CIR Response

CIR #41

Carleton Place Arena
Renovation and Addition

CIR # 41
Architectural Requirements

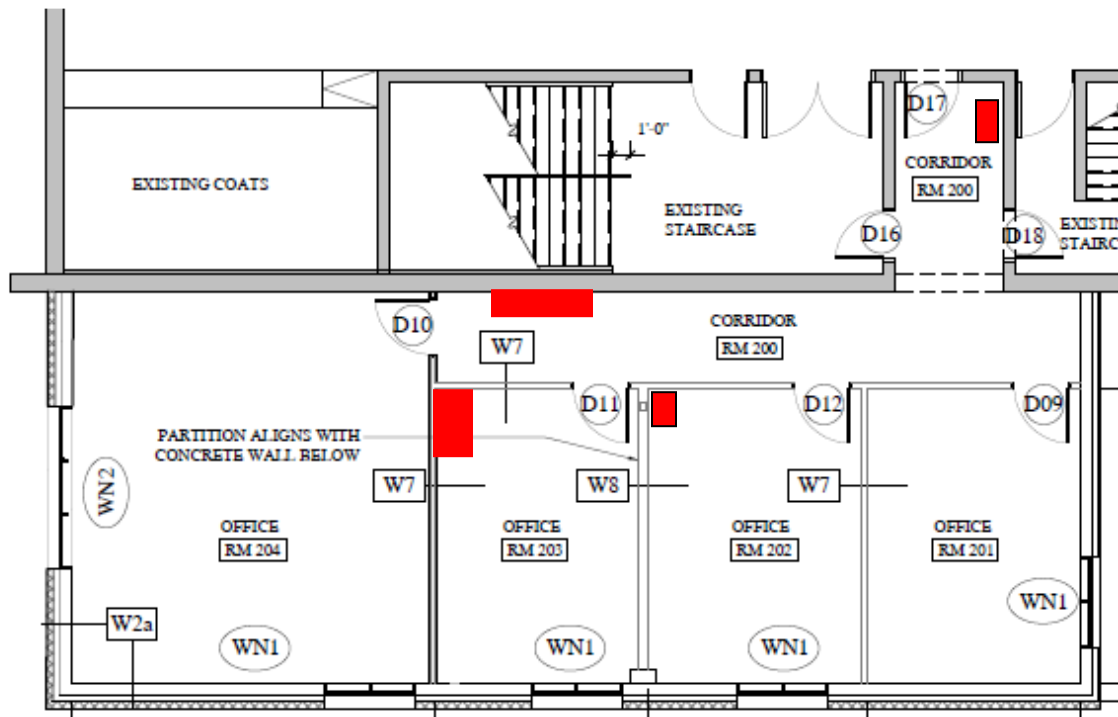
Please provide the Architectural treatment requirements for the currently exposed mechanical work at the locations indicated in “red blocks” below. Are these installations to remain as is, do they get painted, hidden by false walls, hidden by bulkheads or is an actual Fire Separation required.

Additionally, please confirm the Fire Separation requirements at all locations of the new addition to the adjacent existing building.

1. The areas indicated in Rooms 202 and 203 will require fire dampers located at the gypsum bd. fire separation, as indicated on the mechanical drawings. It is intended that these vertical ducts be enclosed with metal framing and gypsum bd. The intention is to minimize the size of the chase.

2. The six pipes from the in Corridor 200 adjacent to door D10 will require fire stop installation at the gypsum bd. fire separation. Initially these pipes were to run horizontally through the floor structure to the exterior wall, however, now that they have been installed vertically to the roof, we should box them in with metal framing and gypsum bd. The intention would be to minimize the size of the projection into the corridor.

3. The roof drain piping located in Corridor 200 adjacent to door D17 does not require any associated work.
4. There are no fire separation requirements between the addition and the existing building as they are both classified as one building.
